Document Update Notification

DOCUMENT NO: OP-1903.068

TITLE: EMERGENCY RESPONSE FACILITY-
EMERGENCY NEWS CENTER ENC

CHANGE NO: 006-00-0

ATTACHMENT 5

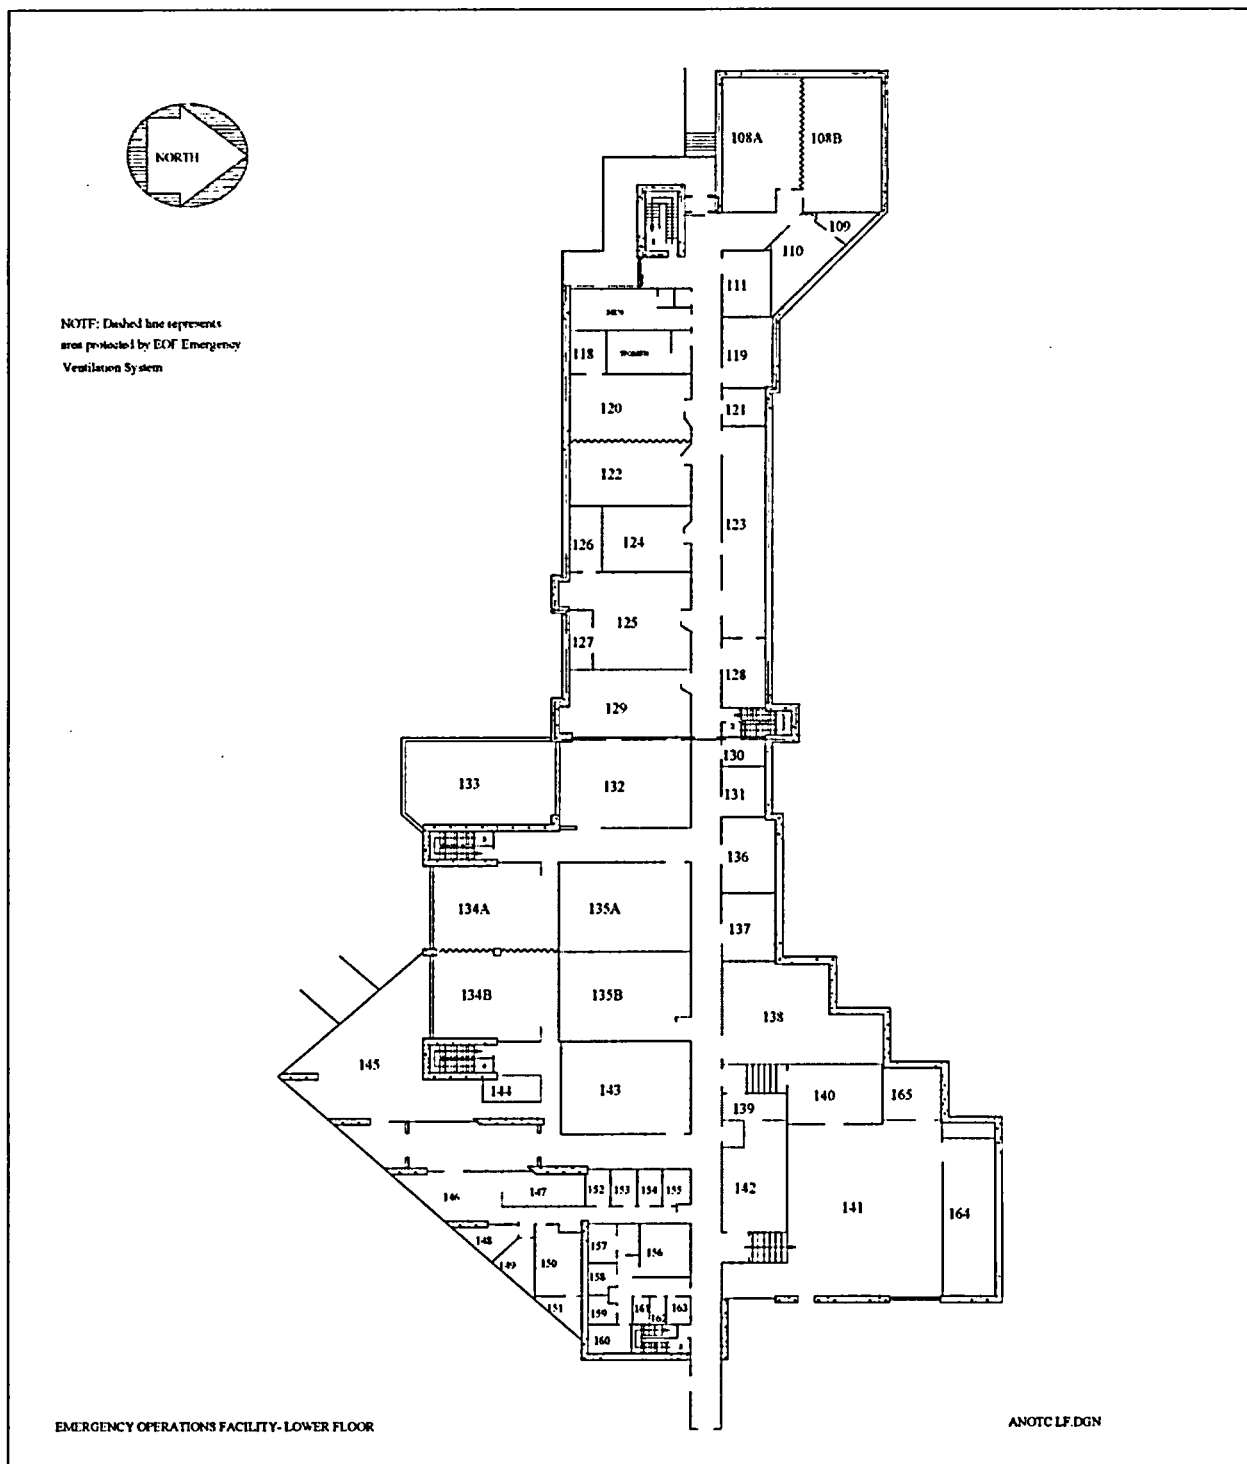
Attachment 5
(Room Assignments)
Page 30

Removed room 144 from list

ATTACHMENT 7

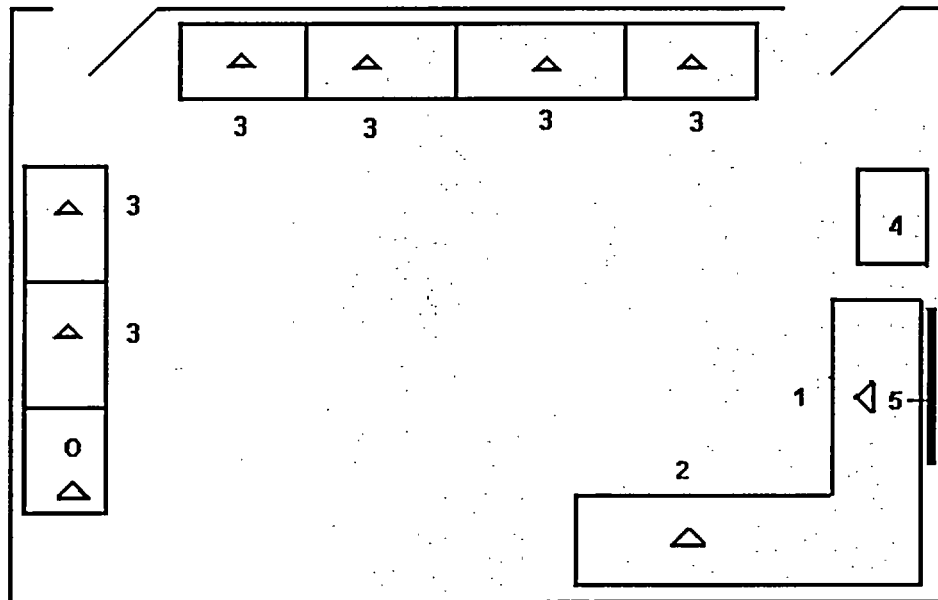
Attachment 7
(ENC Room Map)
Page 33

Revised room map for room 240 (ENC) to reflect current arrangement and equipment
